Product Change Notification

USB 3.0 Optimization

PCN Number:	CTIU-00008
Revision:	0.01
Issue Date:	2018-01-08
Effective Date:	2017-12-10
Authors:	TH

3.4 Mechanical Compatibility

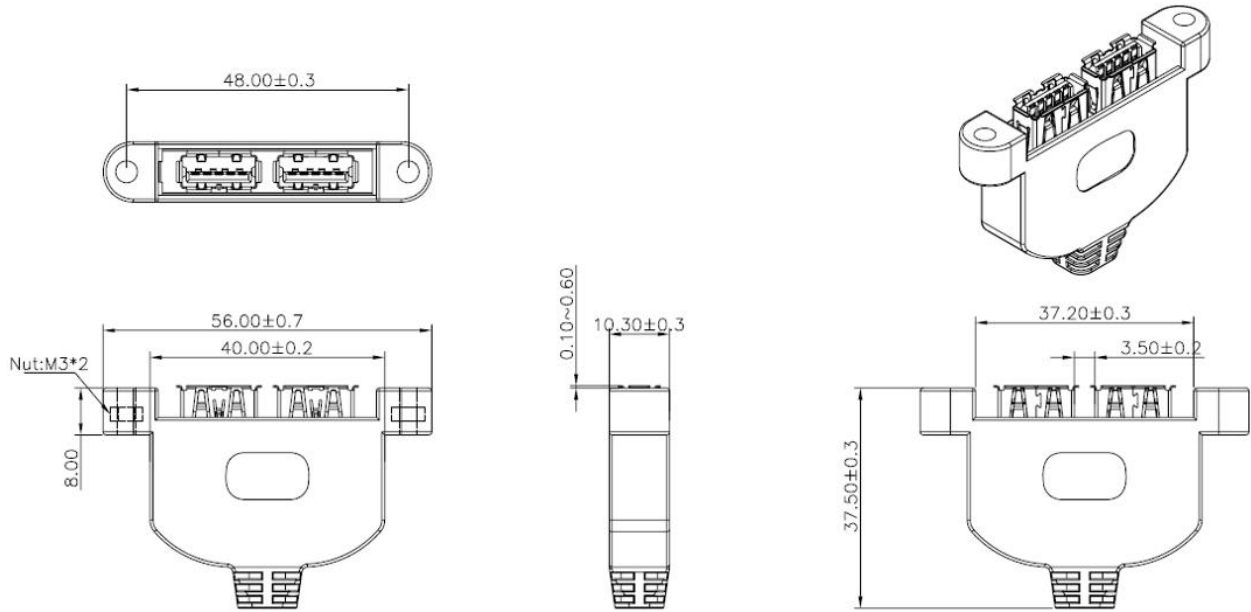
As part of the USB 3.0 optimization of CTI products, CTI no longer recommends CBG131 and CBG133 for new designs. CTI will continue to offer and support these cables for existing systems. See cable images below; CBG131 is on the left and CBG133 is on the right.

Cable colour, length and panel mount geometries are different between the old and new cables. See below for more information.

For new designs CTI recommends CBG160, CBG287, and CBG288.
